## SB-10058273-5500

**Service Action: Drive Module Harness Edge Protection**

I12 (i8)

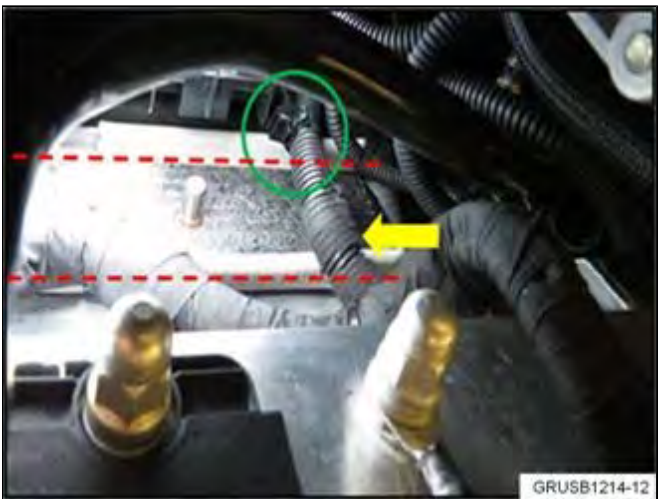
3. Cut the edge protection into two pieces, 200 mm (approximately 8") long.
4. Secure each edge protection piece to the Carbon Fiber (CFRP) flanges above and below the ISOFIX mount, as shown in red. This is located on the rear bulkhead of the vehicle.

NOTE: The CFRP flange is very sharp, so gloves should be worn for this step.

5. Secure the wire tie retaining clip to the plastic DME bracket as shown.
6. Secure the wire tie to the corrugated tube.

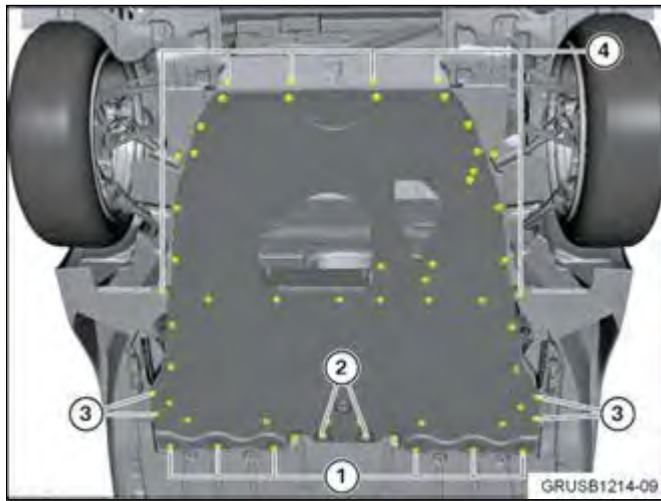
7. Verify the installation as shown, which includes:
  - Corrugated tubing already present – yellow arrow
  - Edge protection on flanges – red lines
  - Corrugated tube wire tied to the DME bracket – green circle

8. Reinstall the thrust plate using new bolts for the forwardmost location (1) and the following

1. 56 Nm + 90° angle torque
2. 56 Nm
3. 8 Nm
4. 3 Nm
5. All remaining screws – 28 Nm
